PLANNING & ZONING BOARD AGENDA

**PLANNING & ZONING BOARD
AGENDA ITEM 7A**

The applicant, Charles Cudd Co, submitted a Land Use Application for PUD Amendment #1. They are requesting an amendment to the PUD Preliminary Plan/Preliminary Plat ("PUD Amendment #1") to construct 13 single-family lots west of Wilkinson Way instead of the approved 20 townhomes lots.

EXAMPLE ARCHITECTURE PLANS FROM CHARLES CUDD CO

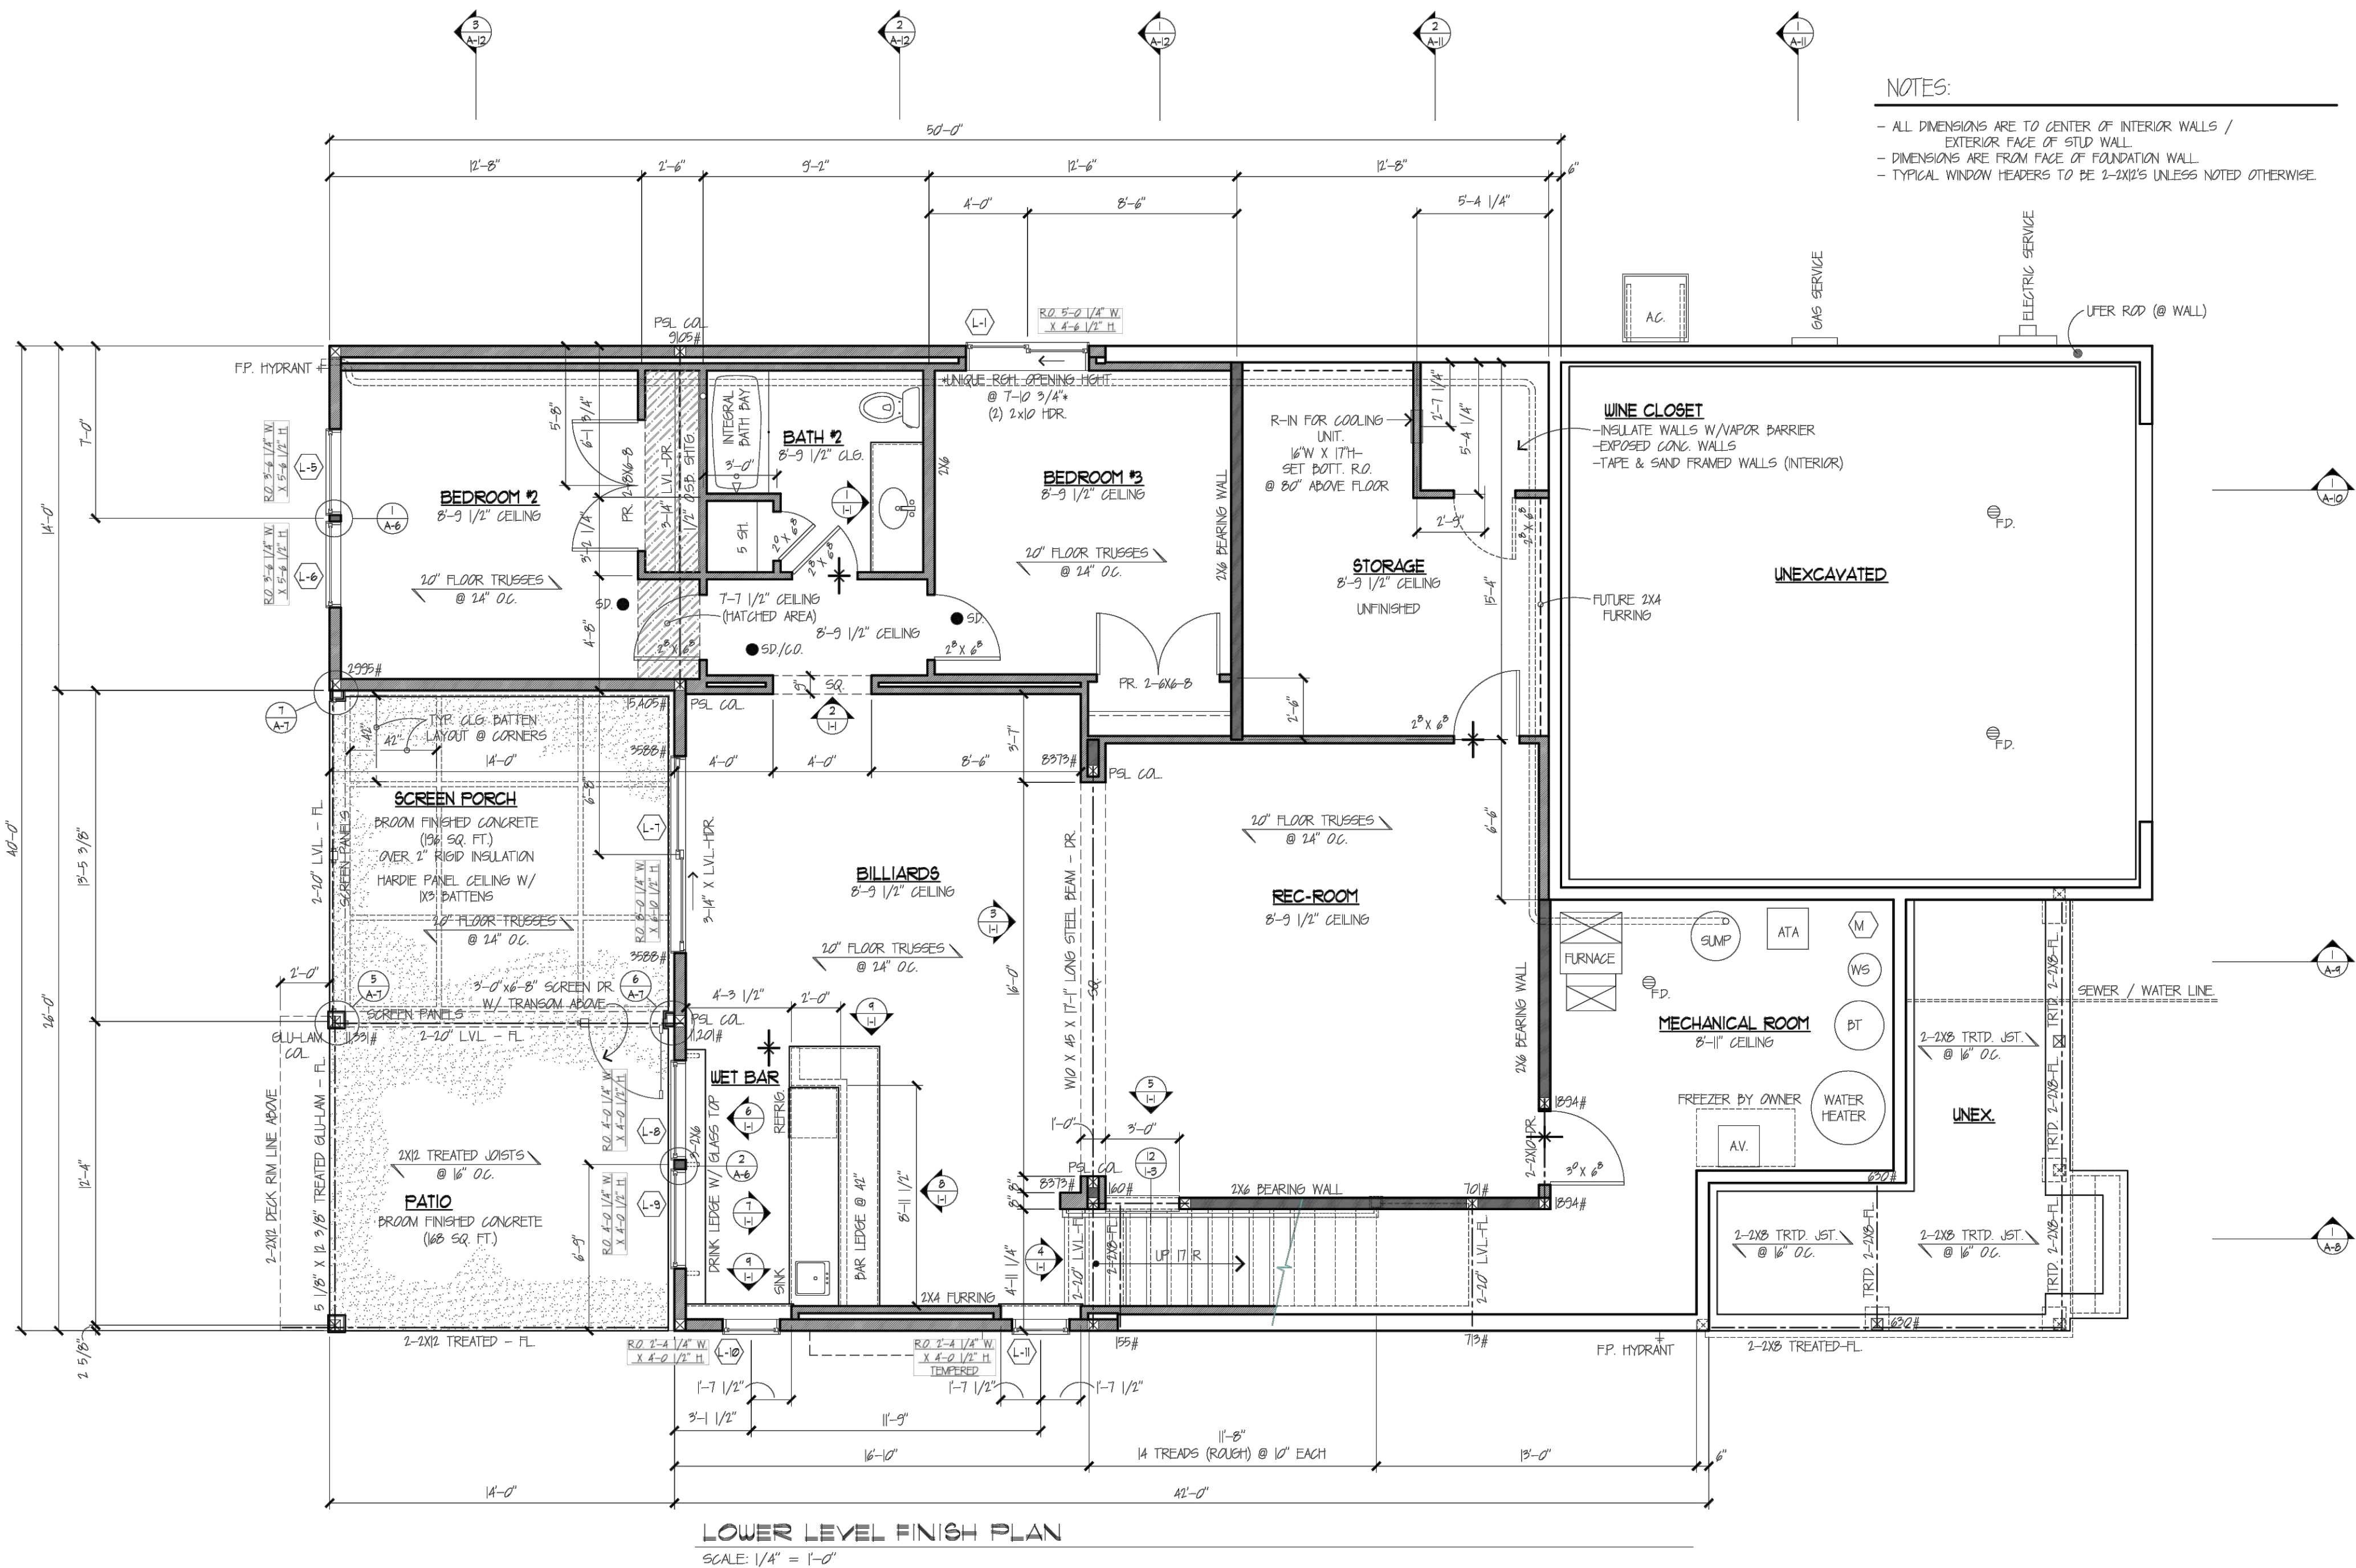
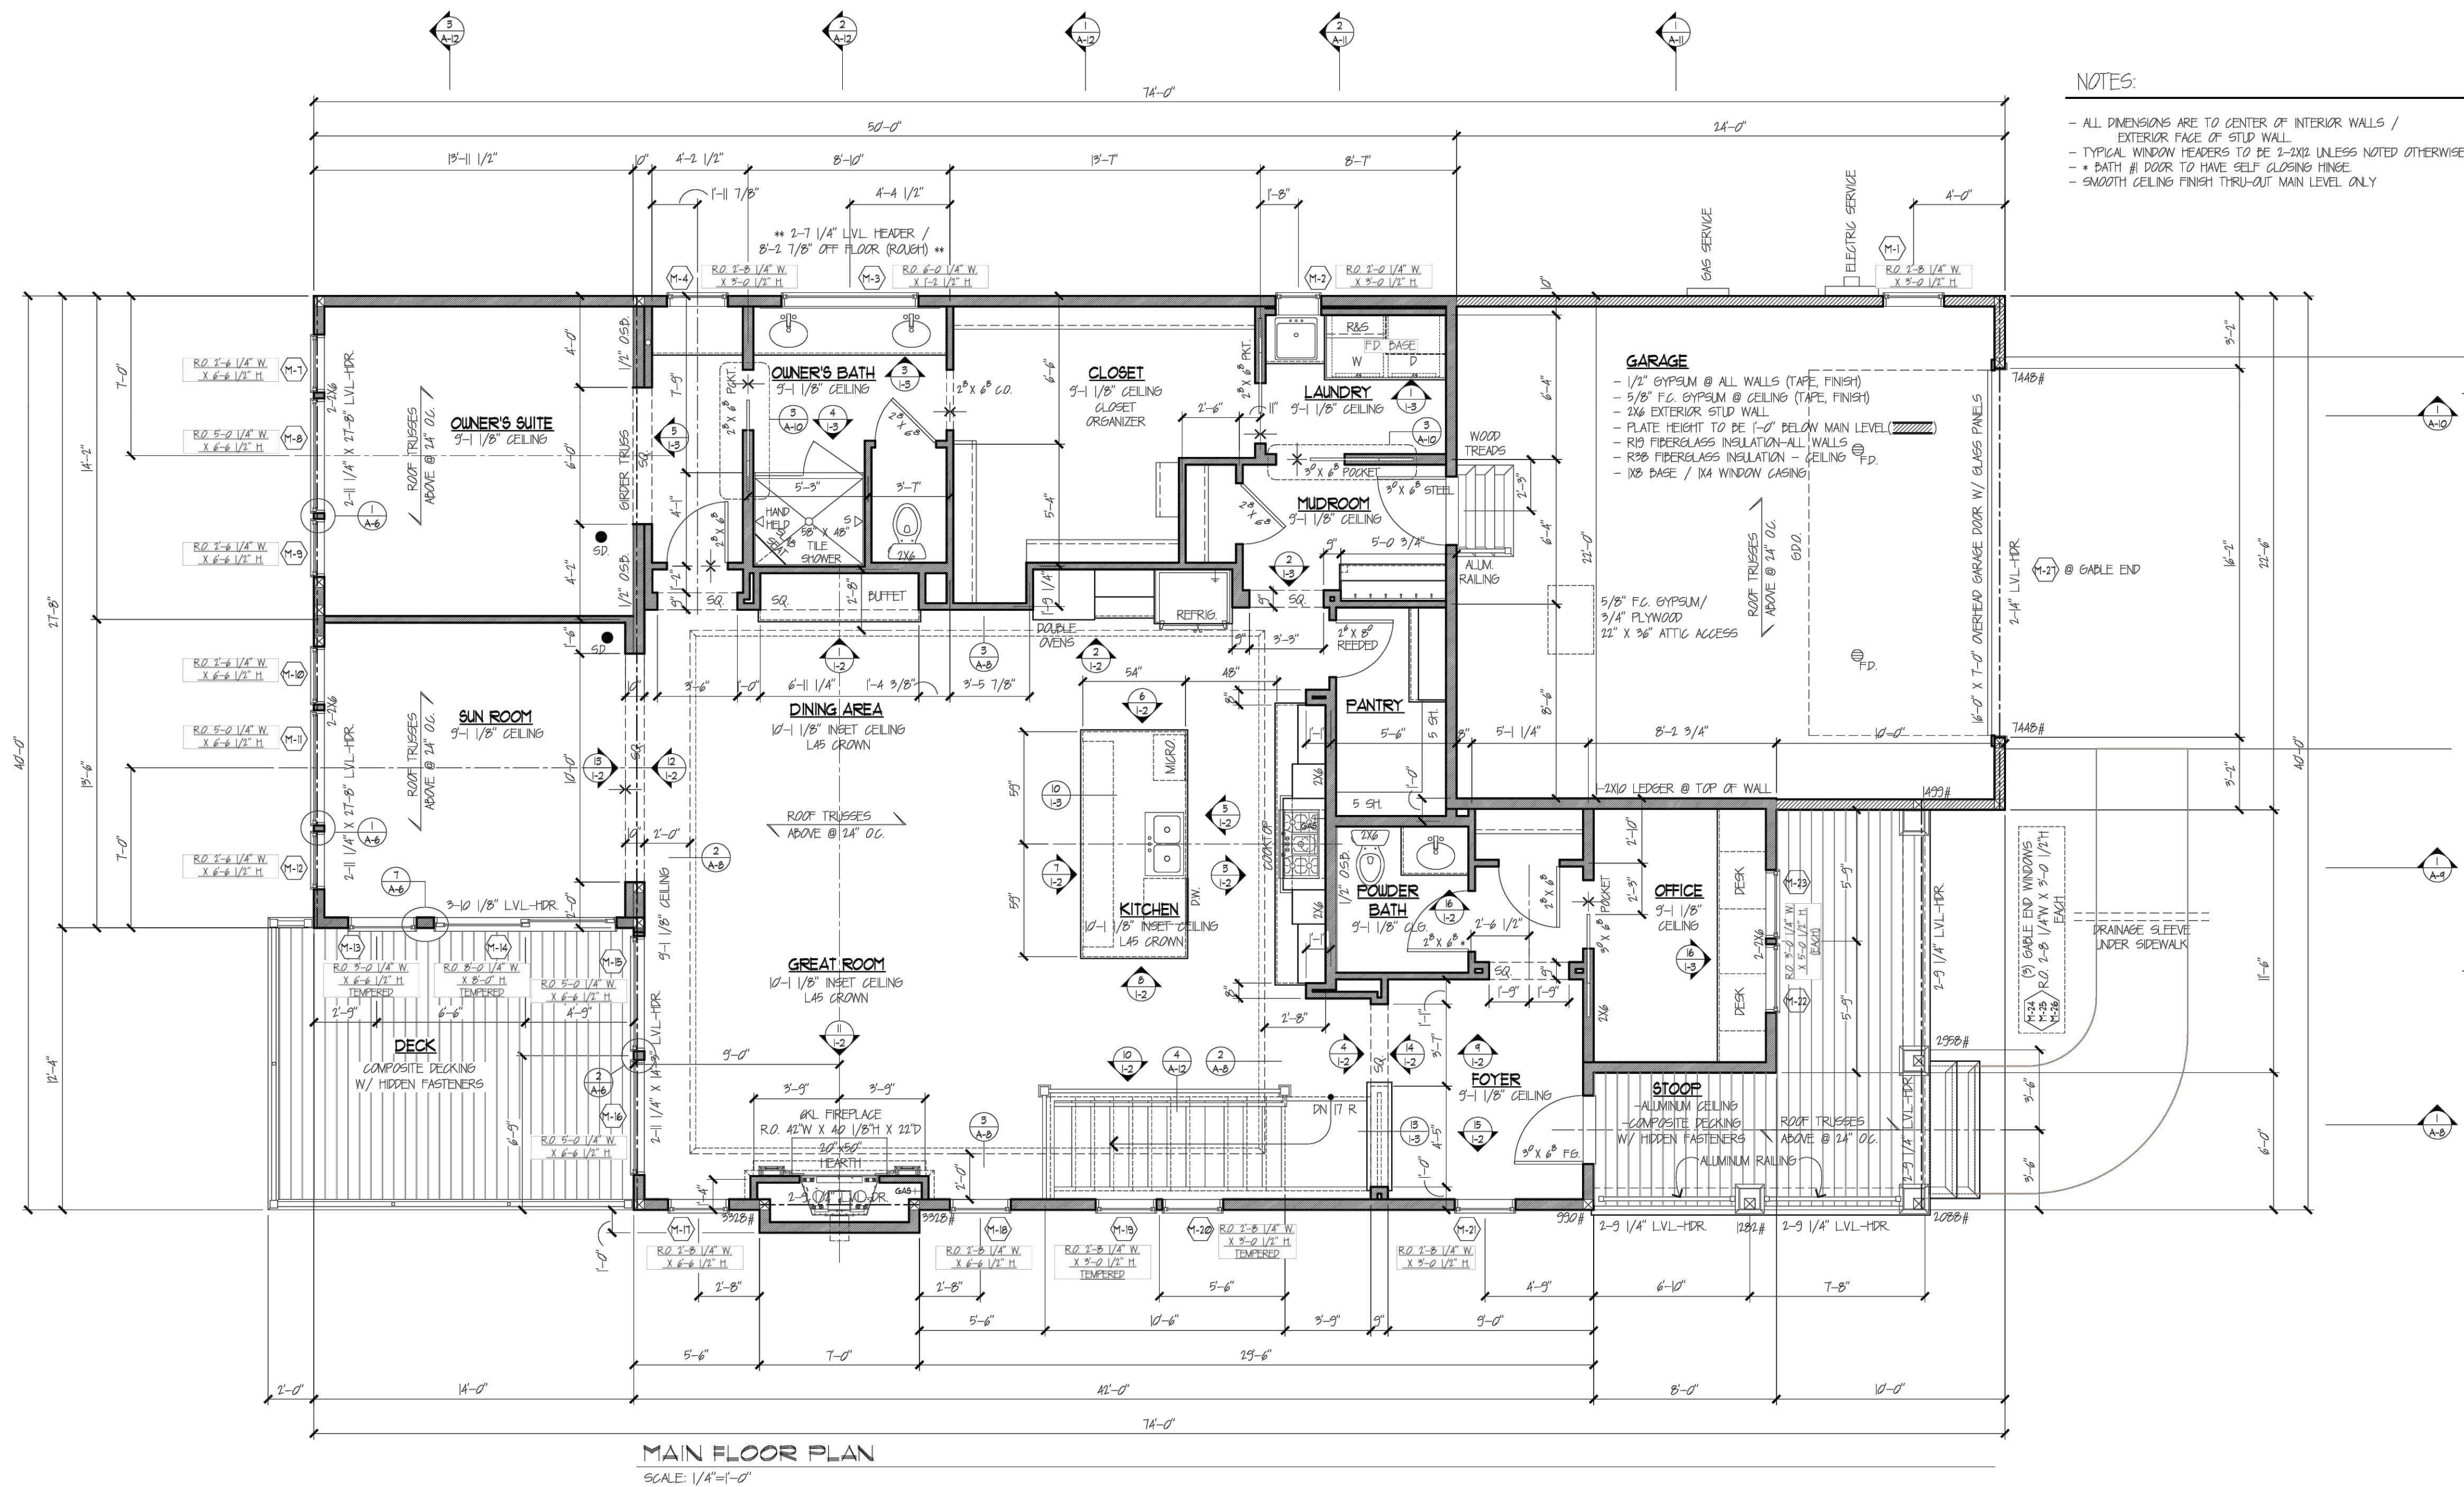
- d. Add information under Proposed Zoning for R-2 requirements.
- 6. All plan sheets for Charles Cudd Co architecture plans:
 - a. Plans shall be to scale.

- b. Plans shall represent house plans that are proposed for construction.
 - c. Air conditioning units shall not be in drainage & utility easements. These may need to be moved to rear yard.
